# UNITED STATES PATENT AND TRADEMARK OFFICE

APPLICATION NO.	FILING DATE	FIRST NAMED INVENTOR	ATTORNEY DOCKET NO.	CONFIRMATION NO.
10/578,321	05/04/2006	Takenori Yoshizawa	1248-0870PUS1	5572

<b>Office Action Summary</b>	<b>Application No.</b>	<b>Applicant(s)</b>	
	10/578,321	YOSHIZAWA, TAKENORI	
	<b>Examiner</b>	<b>Art Unit</b>	
	Stanton L. Krycinski	3637

## DETAILED ACTION

**Figure 10A. Yoshizawa et al. (US Patent Application Publication No. 2004/0145697 A1).**

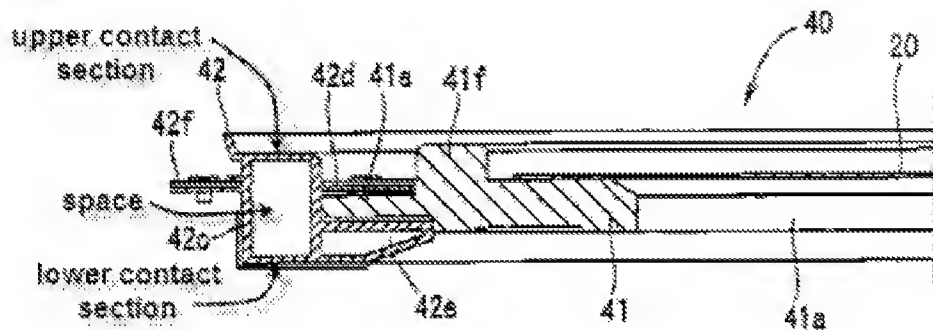
15. In regards to claim 79, Yoshizawa teaches a stackable substrate carrying tray (40, Fig 9A) for placing a substrate (20, Fig 10A) horizontally thereon, being stackable by making an upper contact section of the substrate carrying tray contact a lower surface of an upper tray and by making a lower contact section of the substrate carrying tray contact an upper surface of a lower tray, comprising:

a loading bed (41, Fig 10A) for loading the substrate (20); and

a frame (42) provided to surround an outer edge (41e) of the loading bed (41), wherein the frame (42) includes the upper contact section and the lower contact section as illustrated in Figure 10A above,

wherein the loading bed (41) includes a frame section (41f) whose inner perimeter is larger than an outer perimeter of the substrate (20).

16. Yoshizawa fails to teach the upper contact section having an upper inclined section and the lower contact section having a lower inclined section, and an upper surface of the frame section (41f) being lower than the upper contact section.

**Figure 7. Irwin (US Patent No. 1,941,941).**

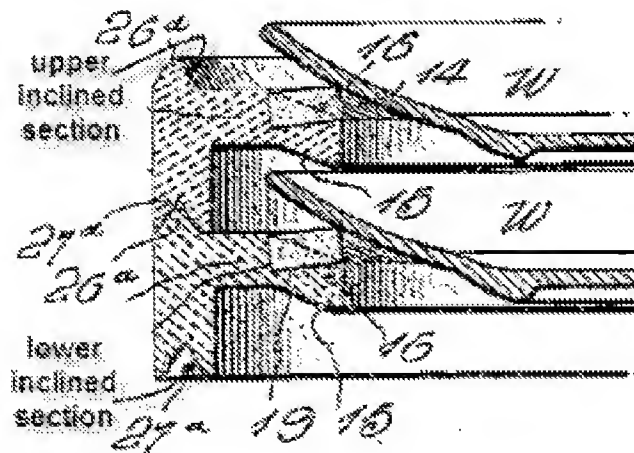
17. Irwin teaches a stackable substrate carrying tray having an upper contact section (26a, Fig 7) having an upper inclined section, and a lower contact section (27a, Fig 7) having a lower inclined section.

22. In regards to claims 85 and 86, Yoshizawa, modified by Irwin and Smith, teaches the lower inclined section has a same inclined direction as that of the upper inclined section as modified by Irwin and illustrated in figure 7 above (claim 85), and wherein the upper and lower contact section are disposed on a peripheral edge of the substrate carrying tray as modified by Irwin and illustrated in figure 7 above (claim 86).

24. In regards to claims 89, 90 and 93, Yoshizawa, modified by Irwin and Smith, teaches an upper inclined section is provided entirely on an upper surface of an upper contact section (26a, Fig 7 of Irwin), and a lower inclined section provided entirely on a lower surface of a lower contact section (27a, Fig 7 of Irwin) as recited in claim 89; and

an upper inclined section is provided on a portion including an outer edge or inner edge of an upper surface of the upper contact section (26a, Fig 7 of Irwin), and a lower inclined section is provided on a portion of the lower contact section (27a, Fig 7 of Irwin), the portion including an edge corresponding to an edge on which the upper inclined section is disposed as recited in claim 90; and
